DEVIATION REQUEST AND DECISION FORM

Project Name : Crossroads North

A deviation from the standards of or in Section 2.3.7.E.2 of the Engineering Criteria Manual (ECM) is requested.

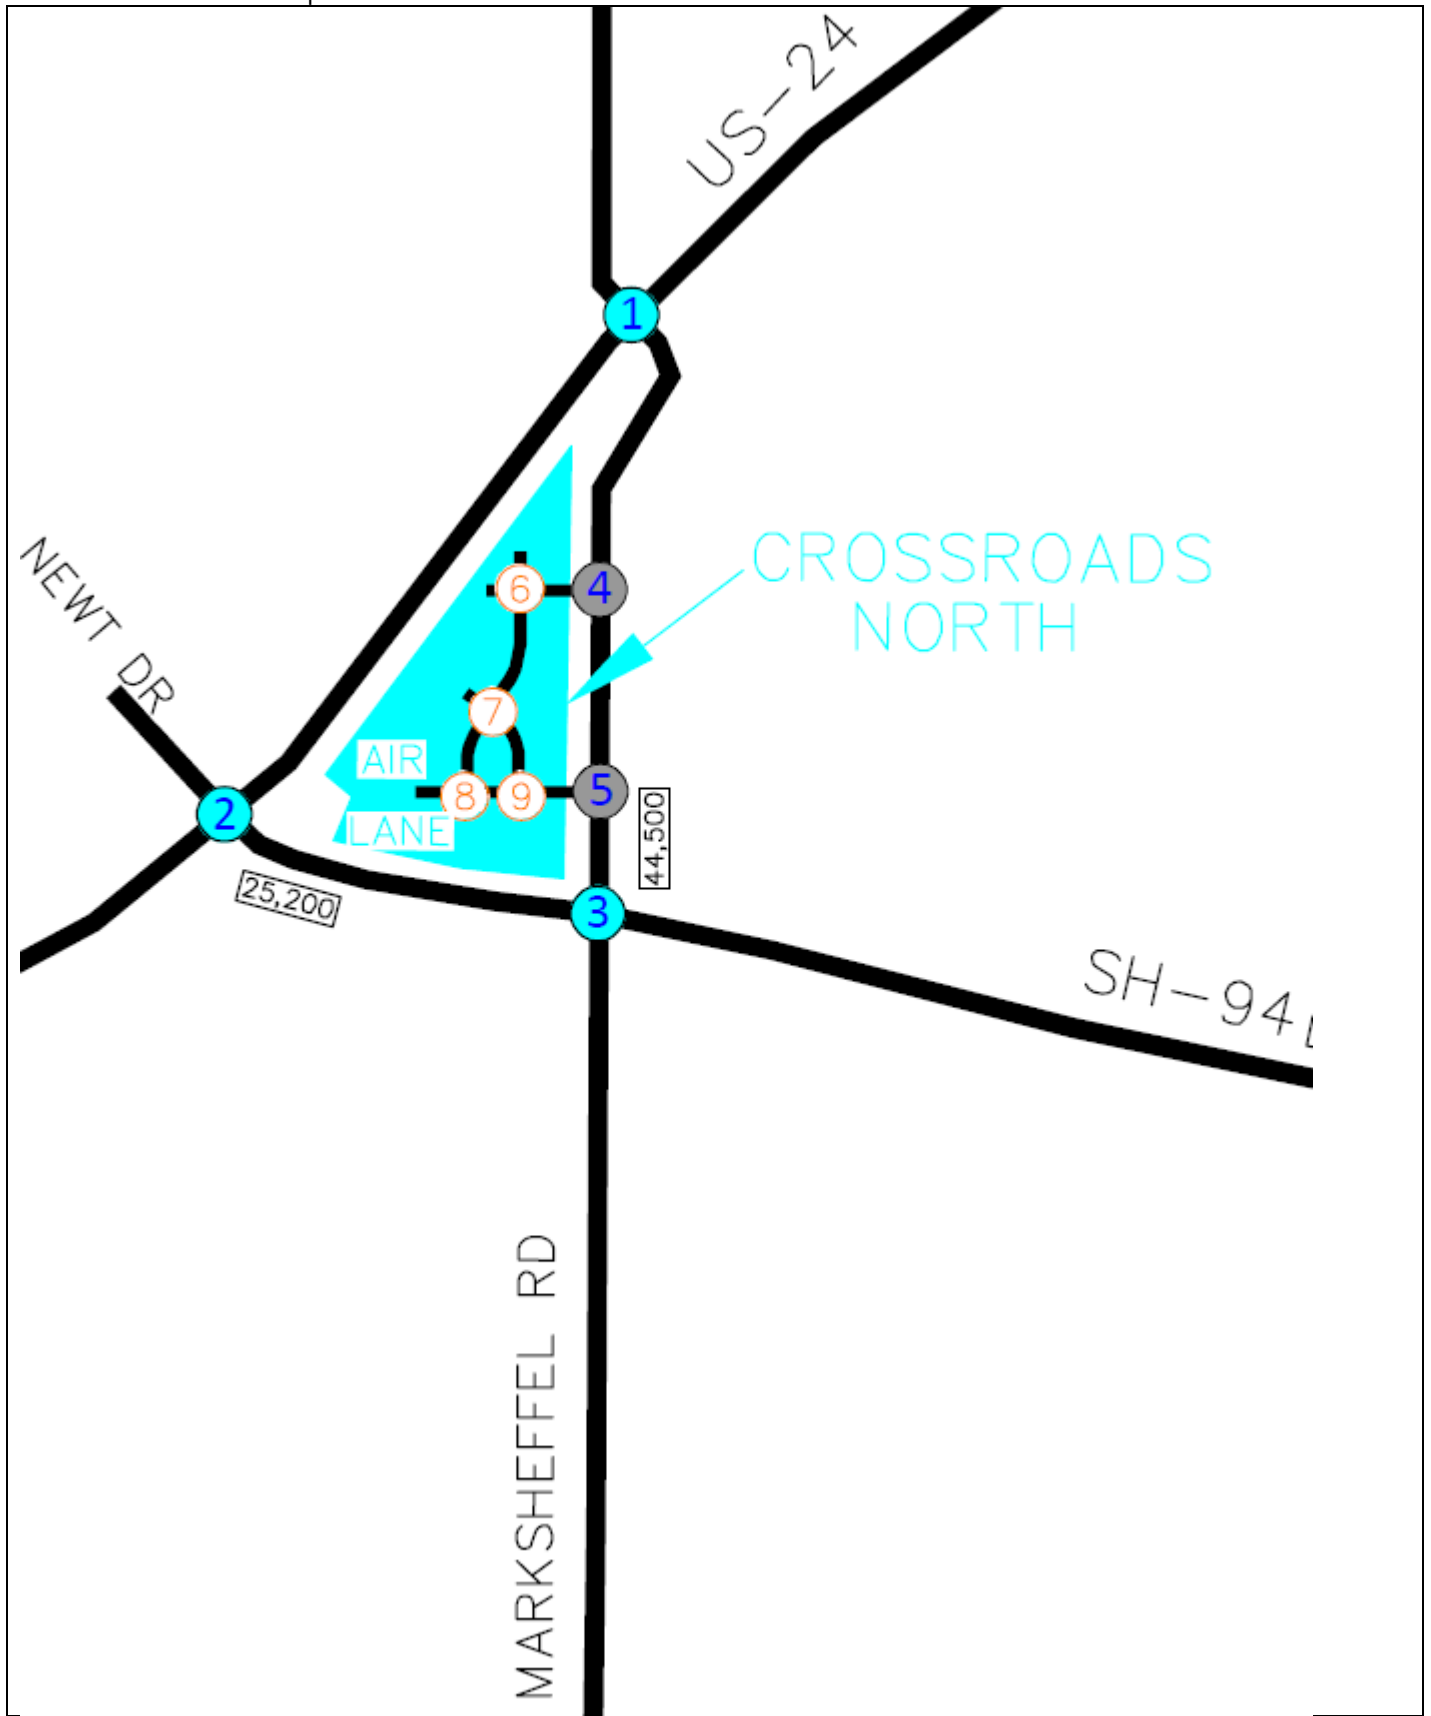
Deviation request will be denied based on City of Colorado Springs comments to design the north access as unsignalized 3/4 movement. Staff recommend withdrawing the deviation request.

3/4 movement will not require a back to back left turns at this intersection (access #4)

The city of Colorado springs require the development to design the north proposed site access (access #4 in the TIA) as unsignalized 3/4 movements intersection, and the proposed south site access (access #5 in the TIA) as signalized full movement intersection.
